ALERT SERVICE BULLETIN

222-17-114
3 March 2017

MODEL AFFECTED: 222/222B

SUBJECT: **MAGNETIC BRAKE ASSEMBLY 204-001-376-105 AND 204-001-376-107, INSPECTION AND REPAIR OF.**

**Figure 1. Magnetic brake assembly.
(Magnetic brake 204-001-376-003 shown as an example in Figures 1 to 4)
(Magnetic brake 204-001-376-105/-107 installed in 222/ 222B)**

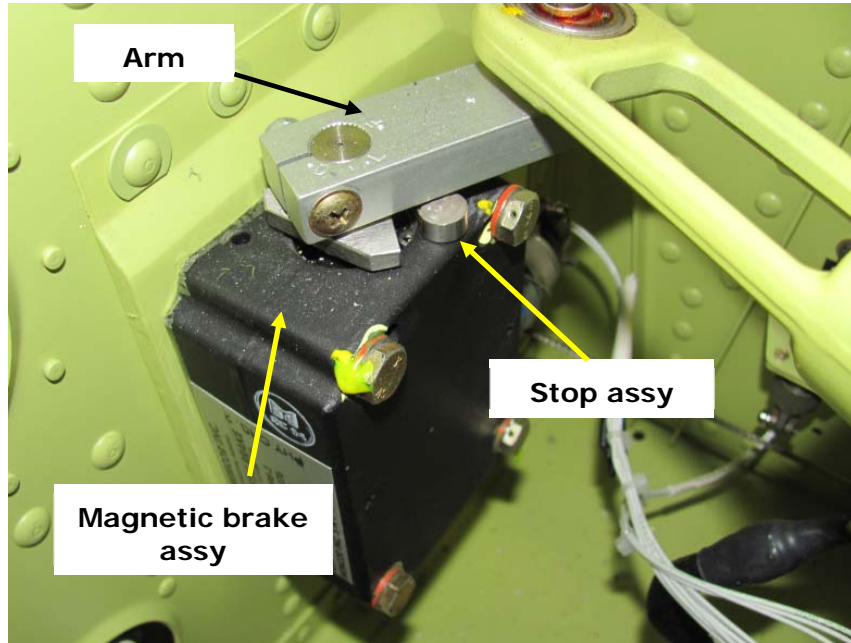
1. Prepare the helicopter for maintenance.
2. Gain access to the fore and aft and lateral magnetic brake assemblies located under the co-pilot seat. (BHT-222/222B-MM).
3. Perform a detailed visual inspection of the stop assemblies (Figures 1 and 2). (Figures 3 and 4) show a stop assembly found disbonded.
4. By hand, pull on the stop assembly to verify if the stop shaft is disbonded from the housing assembly.
5. If the shaft shows evidence of disbonding, inspect the lower side of the arm for possible chafing damage and carry out Part II. The maximum allowable mechanical damage is 0.030 inch (0.762 mm).
 - a. Using a 220-grit or finer aluminum oxide abrasive cloth or paper, polish out mechanical damage found within the allowable 0.030-inch (0.762 mm) limit.
 - b. Apply aluminum alloy chemical film treatment to the repaired area. (BHT-ALL-SPM).

Figure 4. Shaft removed from housing.

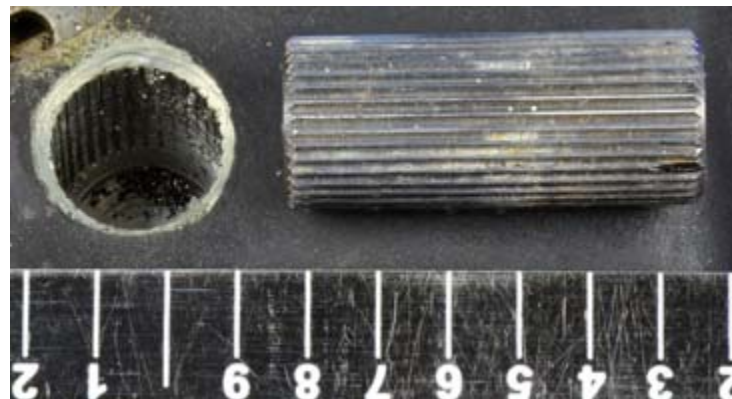
1. Disconnect the helicopter battery.
2. Remove the magnetic brake assembly (BHT-222/222B-MM).
3. Mark the stop assembly and the housing for installation at the same location.
4. Pull out the stop assembly from the housing.

5. Thoroughly clean adhesive residue from the shaft and the housing bore (BHT-ALL-SPM). If the splined stop requires removal from the shaft, index mark the stop, the shaft and the housing to ensure installation at the same location. If the screw is removed from the shaft, reinstall with Loctite (C-320) and torque to 5 to 10 inch-pounds (0.56 to 1.13 Newton-meters).

6. Apply adhesive (C-317) to the mating surfaces of the housing and the shaft.
7. Install the stop assembly in the housing bore and remove excess of adhesive.

Figure 5. Angle of Arm on magnetic brake 204-001-376-105/ -107

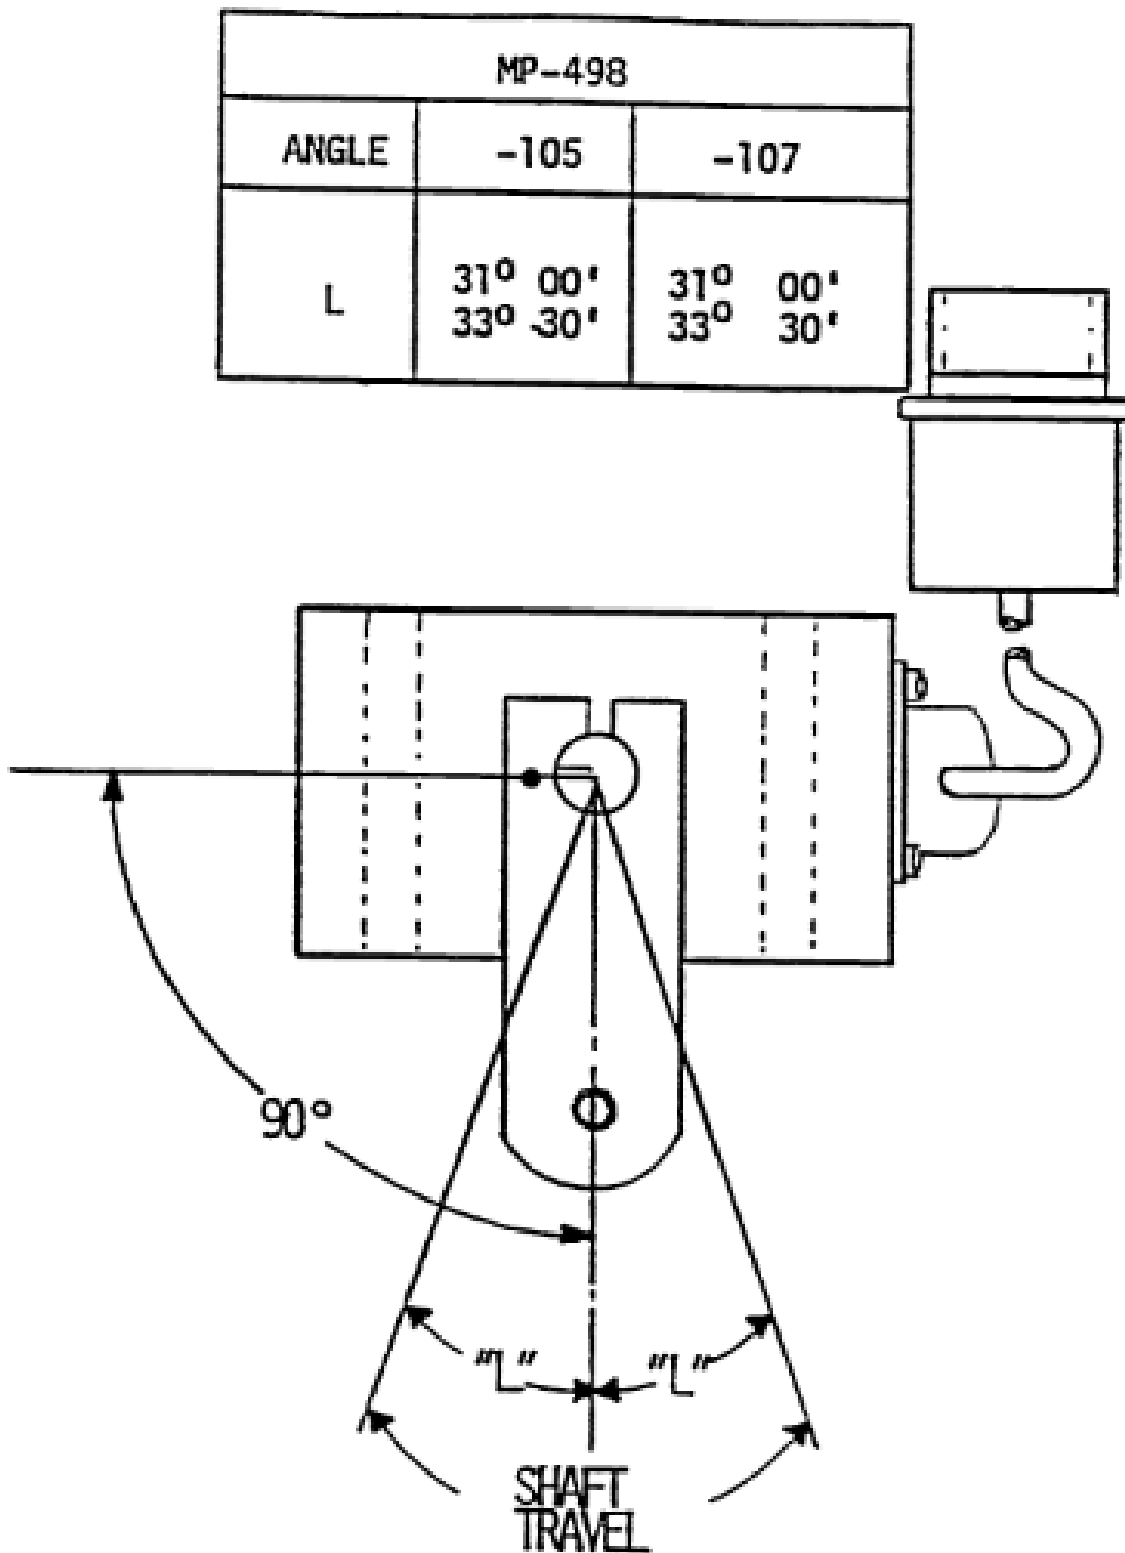
8. The shaft should protrude from the housing surface between 0.180 inch (4.57 mm) and 0.200 inch (5.08 mm). (Figure 2).
9. Allow sufficient time for the adhesive to cure 24 hours at 70 to 95°F (21° to 35°C) and return the magnetic brake assembly to service. Verify/adjust stop limits to achieve the arm assembly shaft travel. (Figure 5).
